Service Bulletin

WideLine rigging hardware torque adjustment

Bulletin #: WLX0001 Issue Date: December 15, 2008

Models Affected: WideLine 8 Series and WideLine 10 Series

Figure 1. Removing the knuckle from the rigging channel.

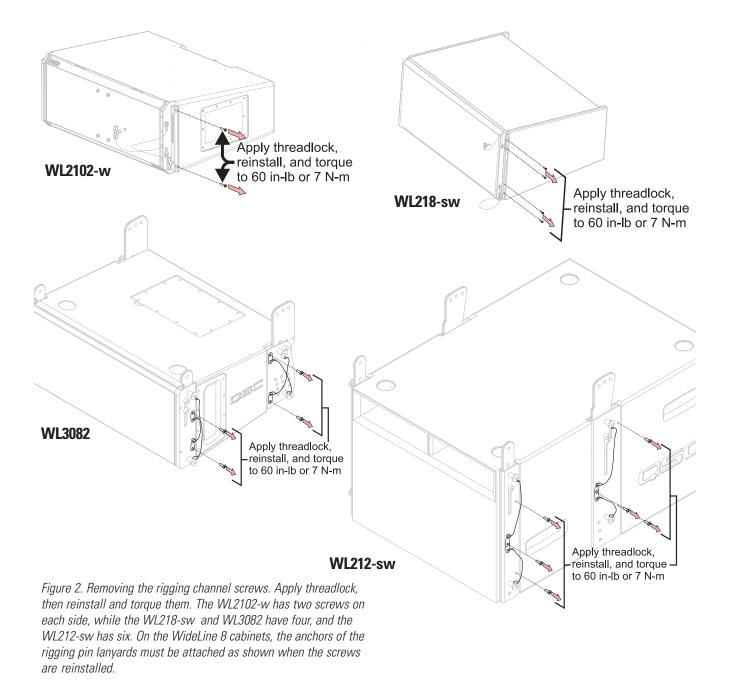
- 1. **WL2102-w and WL218-sw only**: Remove the knuckle from the rigging channel by first unscrewing the TORX cap head screw and then sliding the knuckle out (see Figure 1). Note the orientation of the knuckle, to ensure proper reinstallation at the completion of this procedure.
- 2. **All models:** Remove the TORX screws that hold the rigging channel or channels to the enclosure (two screws and one channel on the WL2102-w; four screws and one channel on the WL218-sw; four screws and two channels on the WL3082; six screws and two channels on the WL212-sw). Apply a dab of Loctite QuickStix 248 to the thread at the end of each screw. See Figure 2.
- 3. **All models:** Reinstall the screws through the rigging channel into the enclosure, using a power drill-screwdriver at its *lowest* torque setting to lightly secure the screws.

Figure 5. Removing the 12 rear angle plate screws. Apply threadlock, then reinstall and torque them.

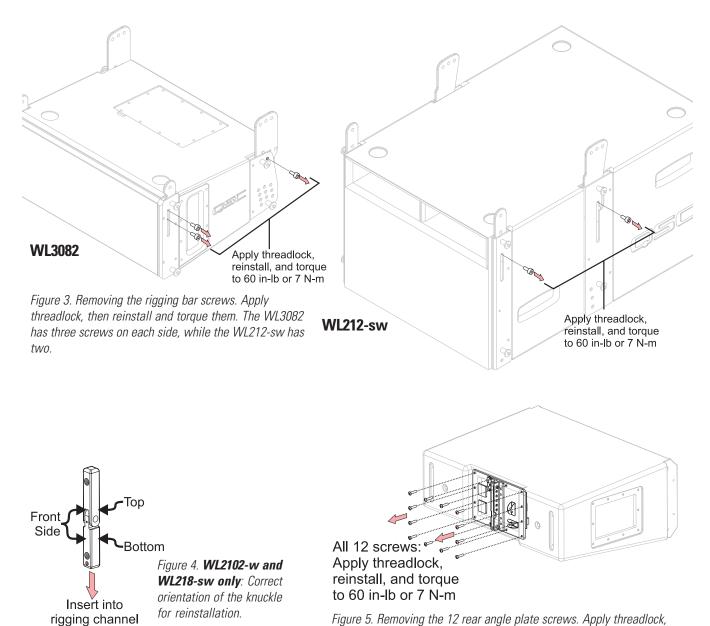
- 7. All models: Repeat steps 1 through 6 with the rigging channel or channels on the other end of the loudspeaker enclosure.
- 8. **WL2102-w and WL218-sw only**: Remove all twelve screws on the input plate/rear rigging point and apply Loctite QuickStix 248.

9. **WL2102-w and WL218-sw only**: Reinstall the screws using a power drill-screwdriver at its lowest torque setting to lightly secure the screws. Torque all of them to **60 in-lb** or **7 N-m** (Figure 5).
